January 11, 2000

SUBJECT: COMMENTS ON THE IMPORTANCE OF CHEMISTRY IN THE NEAR FIELD
TO DOE's YUCCA MOUNTAIN REPOSITORY LICENSE APPLICATION

CHEMISTRY IN THE PROPOSED YUCCA MOUNTAIN REPOSITORY NEAR FIELD

Figure 1. Waste Package and Drift Design Cross Section

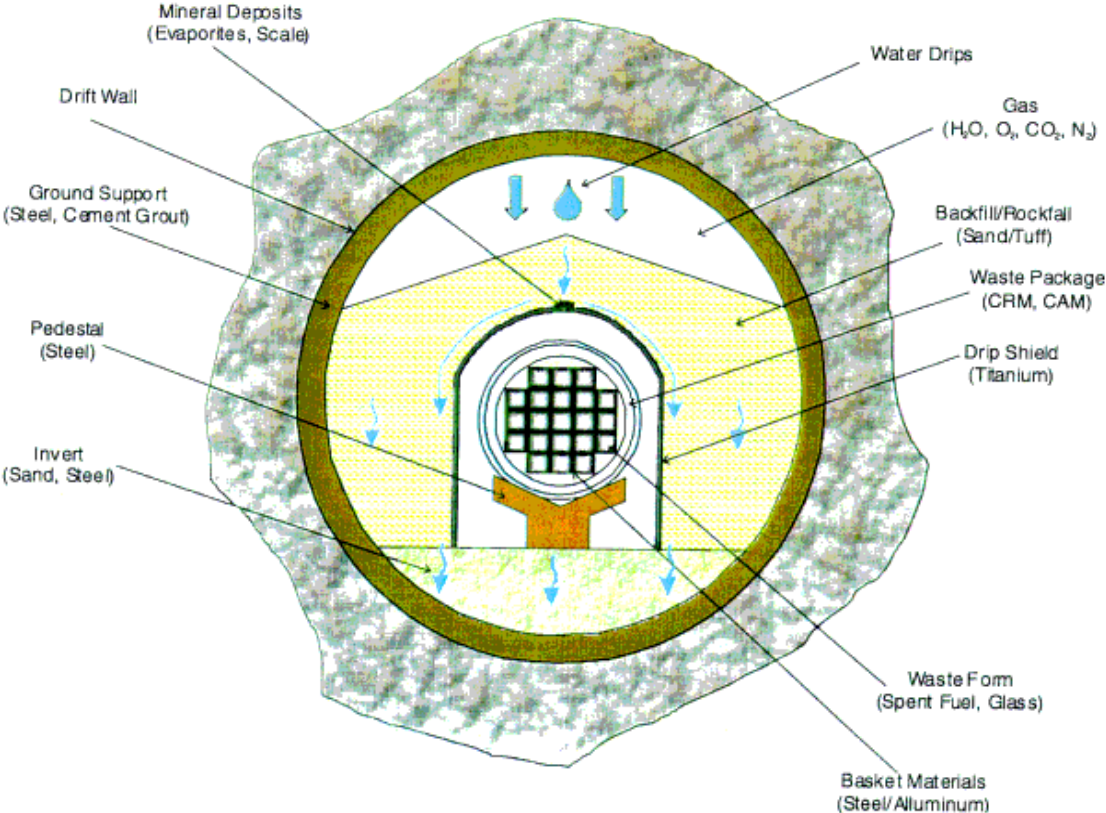
The current waste package design is shown in cross section Figure 1. The outer container has a 2 centimeter-thick wall of alloy C-22, whose composition is given in table 3. The inner container has a 5 centimeter-thick wall of stainless steel. It is expected that the stainless steel will corrode much faster than the C-22 once water breaches the C-22, and that in times far shorter than the repository licensing period it will be completely oxidized provided that the C-22 is in fact breached. As noted above, this steel could produce locally reducing conditions in the waste package or drift, and if oxidized, will add to the ionic iron content of the water. (Iron corrosion products would occupy more volume than the stainless steel from which they come, leading to potential adverse mechanical and structural effects. However, these effects are not considered here.) Unlike the steel in the waste package support and the steel invert, the iron ions from the stainless steel in the waste package container will be available for chemical reactions with the waste form itself at the water-waste interface.

The influence of temperature, and the possible existence of a temperature regime where corrosion is expected to be greatest, must be investigated. It is hypothesized, for example, that at temperatures above about 100° C, water will be driven away from the drift, thereby eliminating corrosion of C-22 for many hundreds or thousands of years. At temperatures below about 80° C, it is hypothesized that the rate of corrosion of C-22 will be so slow as to virtually eliminate corrosion. This hypothesis of a *critical temperature regime* illustrates the important role temperature plays in the chemistry of the repository. It also stresses the importance of repository design in determining temperatures, and thus chemistries, of important chemical processes such as corrosion.
